**Re: Objection – Planning Application PAX92.324279
Ballincor Wind Farm, Co Offaly/Co Tipperary**

We, Cathal & Carol Miller, wish to formally and strongly object to the proposed Ballincor Wind Farm Development. PAX92.324279. We are Receptor 261, as allocated in the above planning application.

The Blackbull Junction – Where the N62 meets the R492

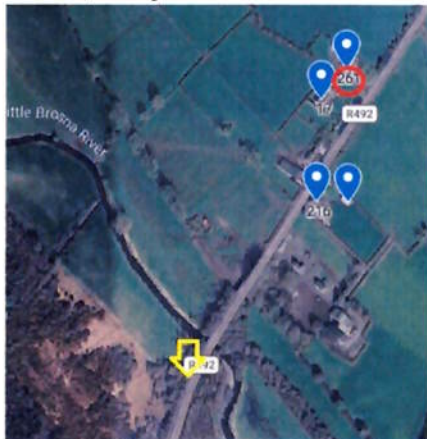
This is the proposed junction where the slow-turning construction vehicles and enormous turbine delivery units will block the road, cause back up traffic, on an already very busy, 100km/h national road. The developer's own figures show that this junction handles 747 vehicles in the evening peak. School buses, farm machinery, and ordinary commuters-including the residents of this road will be caught up in these queues. Moreover, any emergency services, doctors and ambulances, needing to access the local Nursing Home, will be caught up in these queues. The developer dismissed this risk by citing 'very low' traffic volumes. This is not the point, however incorrect. The point is this junction was not made for serving a convoy of delivery trucks, slow-moving HGV's or AIL vehicles turning from the high-speed N62 onto the narrow R492, causing back-ups onto the national route, while waiting for the junction to clear.

The Stage 1 Road Safety Audit the developer cites is a preliminary desktop analysis based on initial design layouts. It does not test the reality of a live construction environment – compromised visibility from dust, seasonal glare, the interaction of turbine delivery convoys with farm machinery and school buses on a road that has never carried this scale of traffic. Stage 1 sign-off is not a risk assessment for what actually happens during construction.

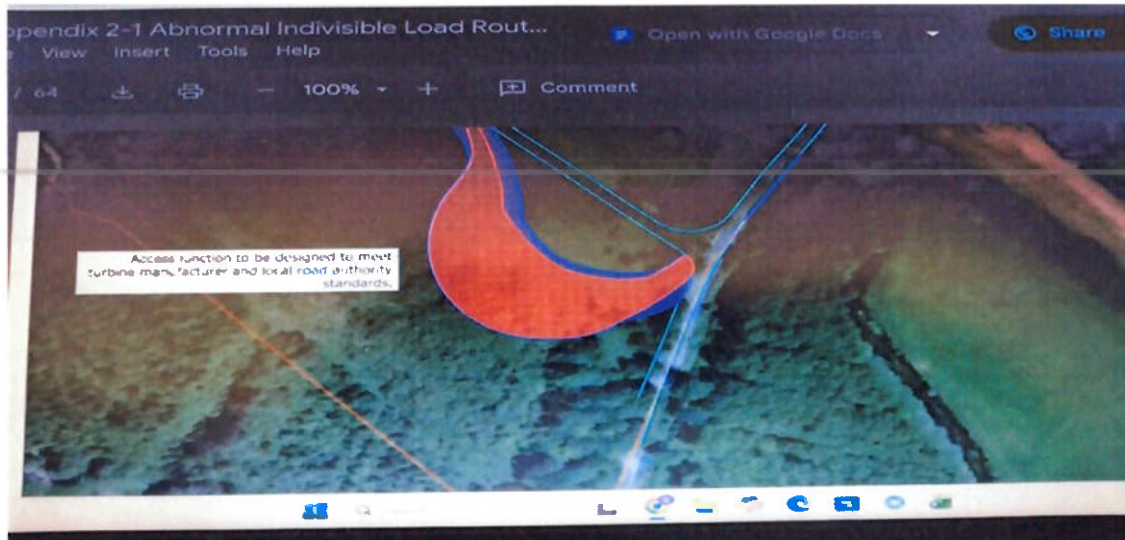
In the applicant's EIAR appendices, Appendix 2-1 Abnormal Indivisible Load Route Summary, the first image below shows the site entrance as misleading, showing a straight road with an exit to the left (which incidentally leads to a bog). The second image shows Drawing SK19, pg62, entrance on the bend coming off the bridge.

Vertical constraints have been identified within the section from this point to the site entrance. Remedial mitigation will be contained within the highway boundary. Swept path drawing SK18 is included in Appendix B.
27 Proposed Site Entrance 	Loads will turn into the proposed site entrance. Full detailed design will be required to confirm the works required to construct the site entrance. The junction should be constructed to meet turbine manufacturer and local road authority standards. Swept path drawing SK19 is included in Appendix B.

- The applicant states on pg2 that Construction upgrades are for two site entrances on the R492 and L1071. This demonstrates to me that there is a third entrance. Two on the R492 ??
